## REMARKS

"Marked-up" drawings

FIG. 3

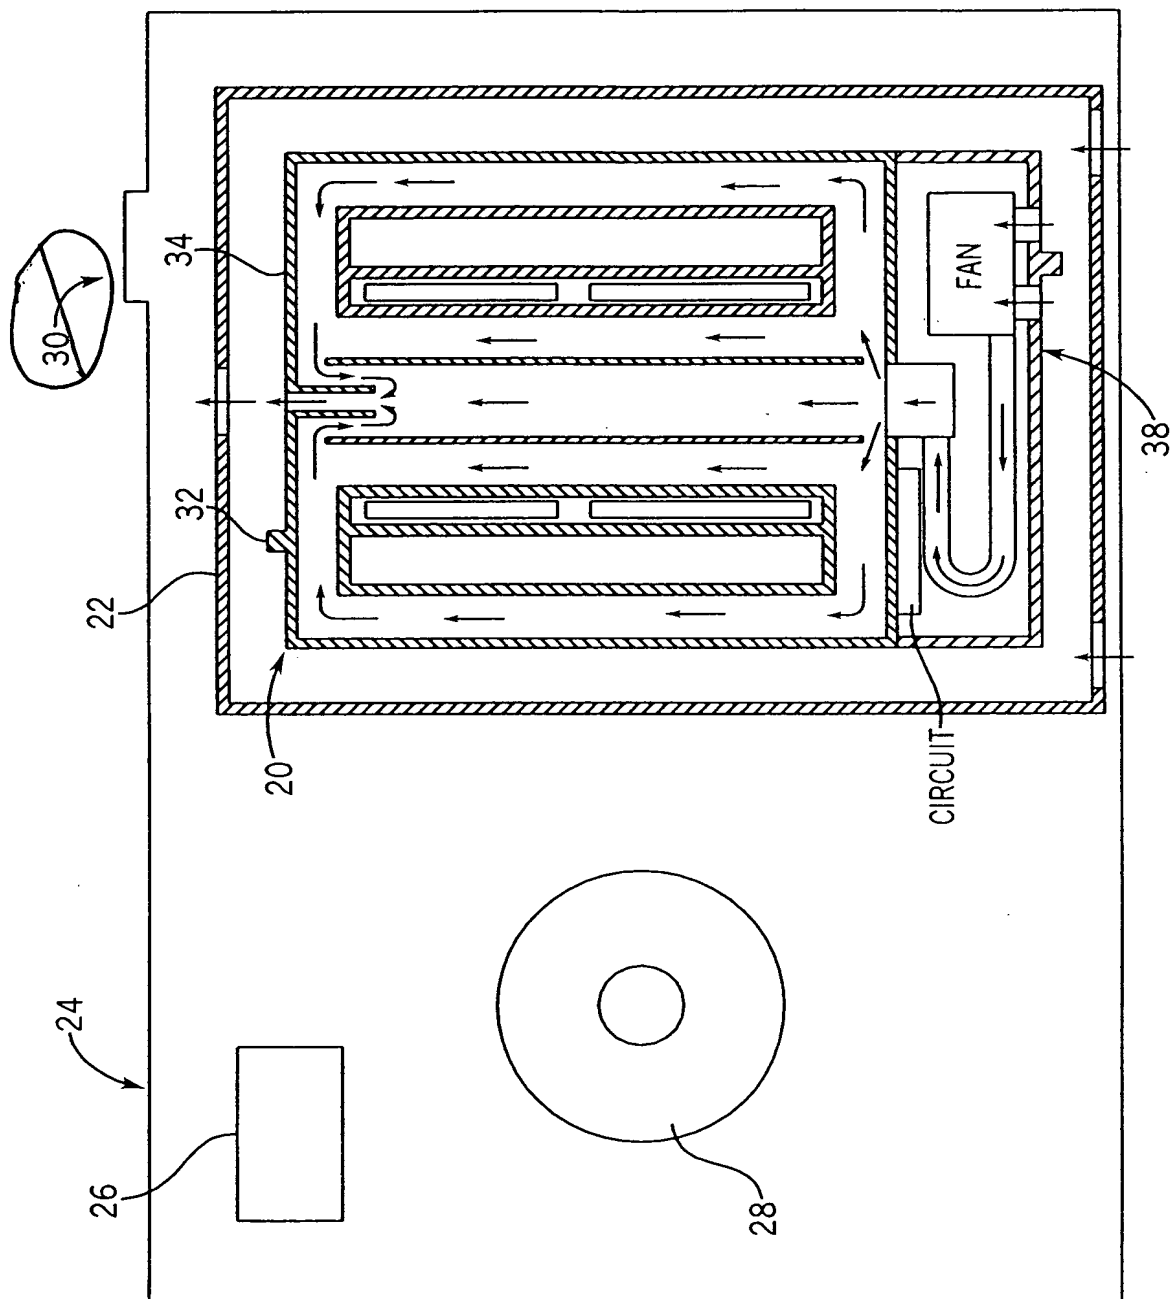
4) Reference numeral 30 of Fig. 3 is not described in the application. Reference numeral 30 has been removed from the drawings.

FIG. 4

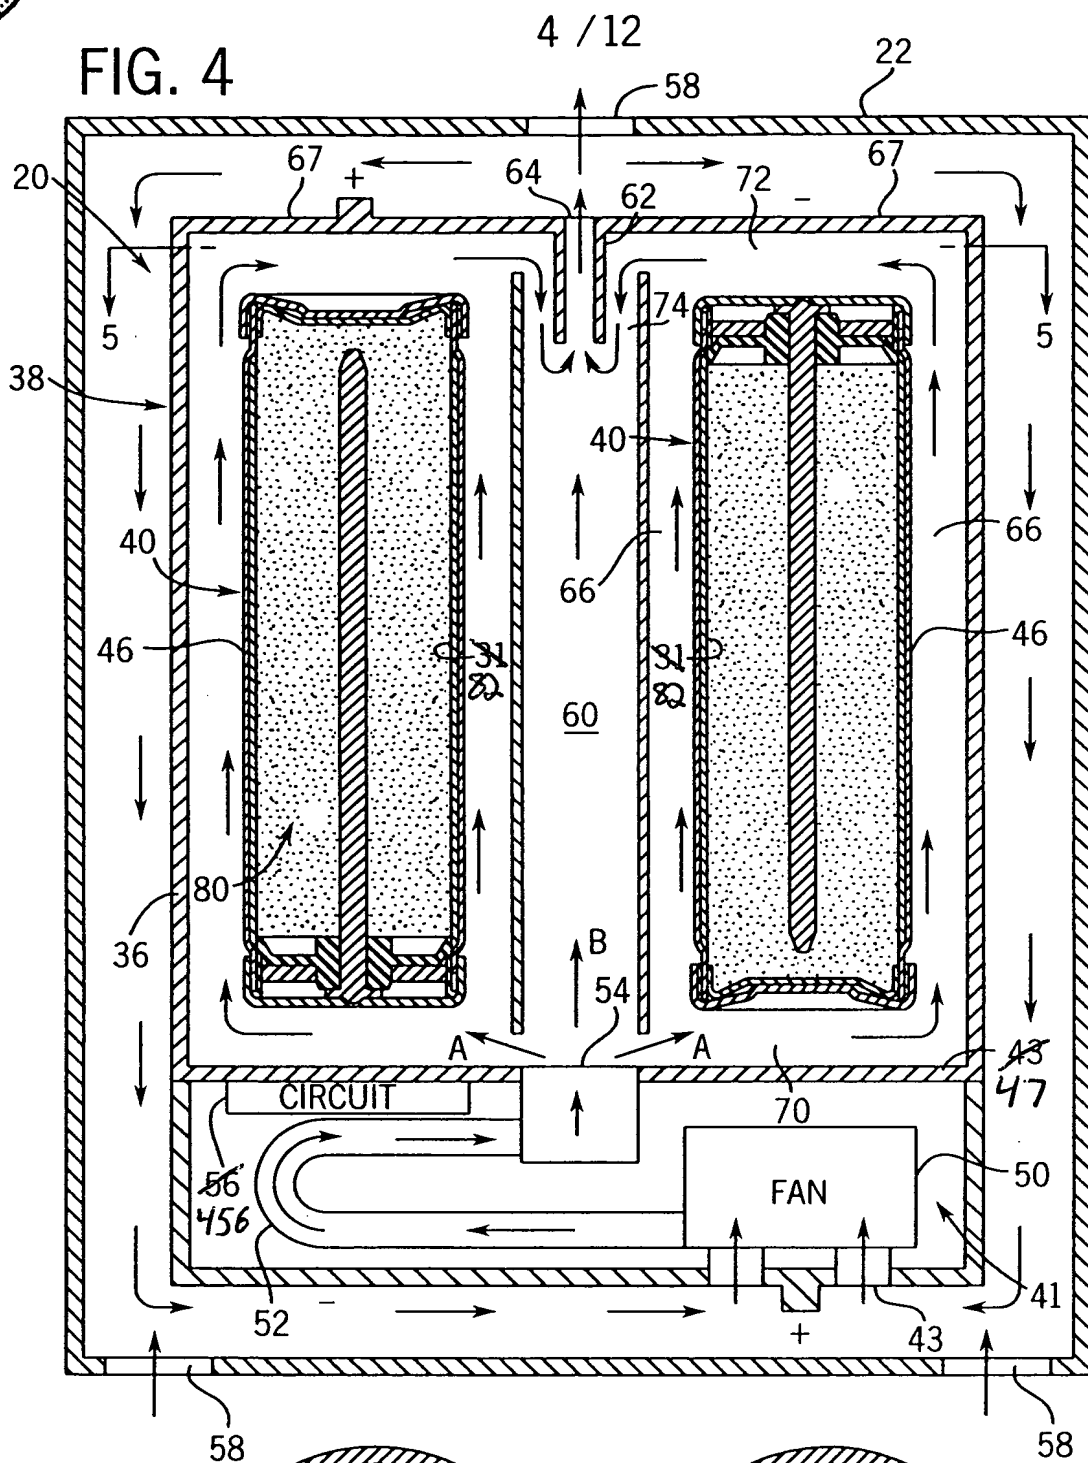
2) Reference character 456 is not in the drawings. In the enclosed “marked-up” copy of Fig. 6, Applicant has drawn a red circle around reference numeral 456 to illustrate that numeral 456 was in the drawings as initially filed. Applicant further encloses marked-up copies of Figs. 4 and 7-9 that, in red ink, change the enumerated circuit “~~56~~, ~~156~~, ~~256~~, and ~~356~~” to “456” for the purposes of consistency with Fig. 6.

5) Reference numeral 31 of Fig. 4 is not described in the drawings. Reference numeral 31, 131, 231, and 331 of Figs. 4 and 7-9, respectively, have been changed to 82, 182, 282, and 382 for the purposes of consistency with Fig. 10.

8) Reference character "243" appears to be drawn to 2 distinct portions of Fig. 8. Applicant further notes that reference numerals 43, 143, and 343 are drawn to the same distinct portions in Figs. 4, 7, and 9, respectively. Applicant therefore amends Figs. 4 and 7-9 to change the divider plate 43, 143, 243, and 343, respectively, to 47, 147, 247, and 347. Applicant has further amended Paragraphs 56 and 61 of the present application to reflect the drawing changes.

FIG. 6

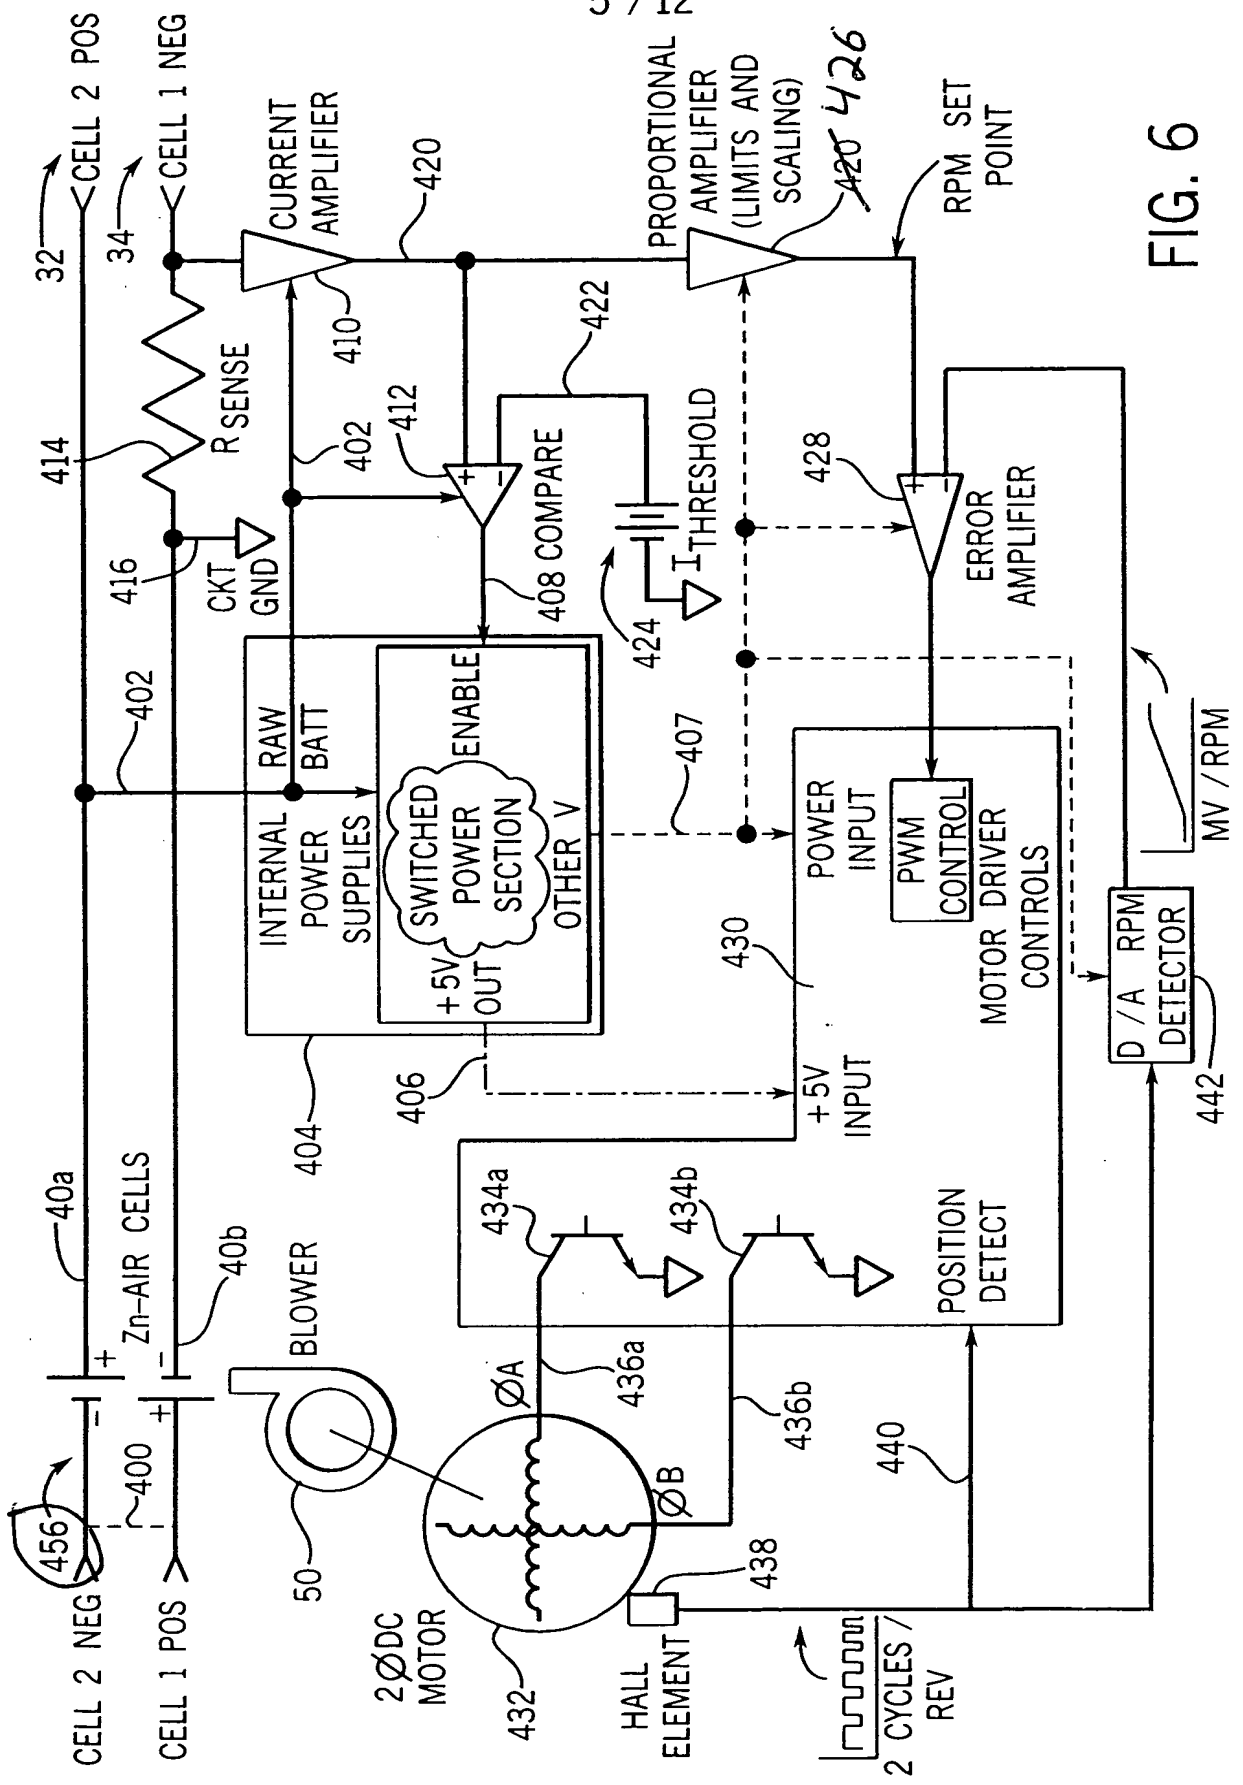
7) Reference character 420 in Fig. 6 has been used to designate both the current amplifier and the proportional amplifier. Applicant has changed the proportional amplifier 420 to 426. This correction is supported by Paragraph 74 of the specification.

FIG. 8

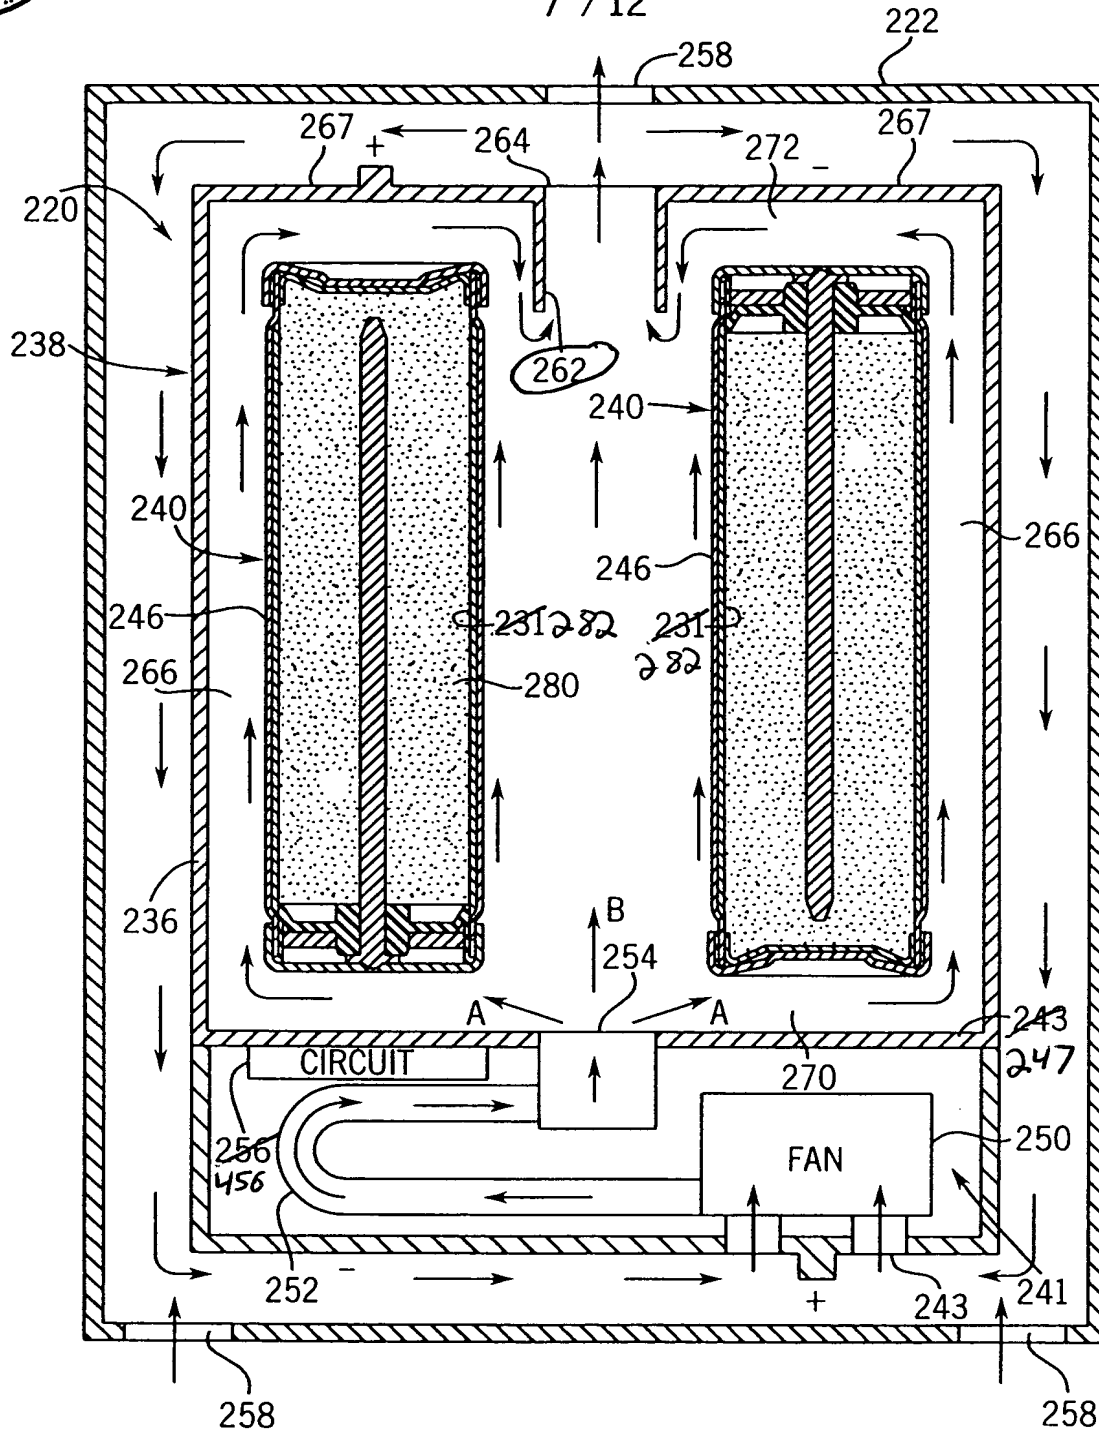
3) Reference character “262” is not found in Fig. 8. Applicant has drawn a red circle around reference numeral “262” to illustrate that numeral 262 was in the drawings as initially filed.
